Well, Councilman Livingston has posted several items on social media from BJCJSTP Staff that are misrepresentations and included an editorial that are potentially slanderous. The items are addressed in the list below:

1. Headworks leaking wall Picture #1, with electrical panels. -

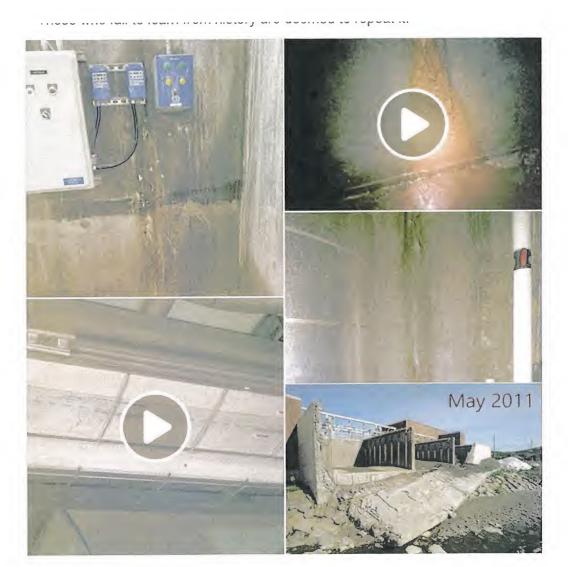
The project manager at the plant assures us that leaks like these in new concrete are normal, and to be expected; they tell us that we're not engineers and we should leave these things to the professionals.

Leading up to the wall collapse in 2011, it was plant personnel who sounded the alarm repeatedly, and nobody listened. You know what they said to us then? They said that leaks like that are normal and to be expected, and that since we aren't engineers we don't know what we're talking about.

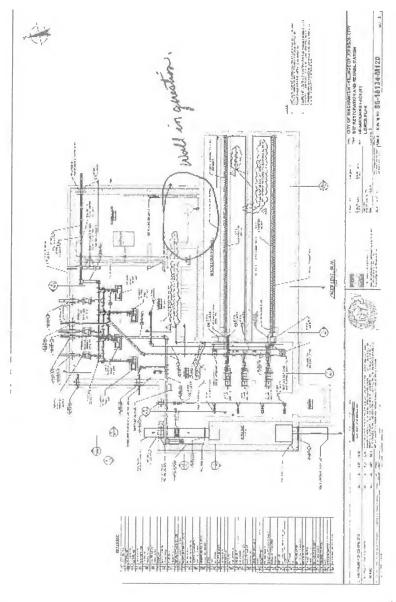
<u>Alleged Condition – STP Staff alleges that the wall is leaking and is shoddy construction.</u>

<u>Alleged Condition -</u> STP Staff also suggest that the control panels are covered in residue, and implying that they could be damaged.

Actual Condition - This photo appears to be several weeks old. The headworks was put into service June 26 It does not show the completed work, and does not show that the leak has been addressed. The wall that the panels are located on backs up to the north grit channel. See attached drawing. The leak test on the channel was passed in January, 2019. All visible leaks were sealed at that time. At the time of the photograph, there are no visible leaks, just past leaks that were appropriately sealed during construction.

<u>Actual Condition –</u> The issue is cosmetic, and it was addressed on the day that the picture was provided. These panels are not damaged. The streaky appearance is from water from the core drill process above the panels which ran down the wall. These panels have already been cleaned

up, and were not damaged in any way. The panels were inspected after the drilling process, and it was confirmed that the panels did not have any intrusion of water into the panels. Furthermore, the manufacturer certified the installation of the panels prior to putting the Headworks on line on June 26, 2019, and they confirmed that there were no warranty concerns.
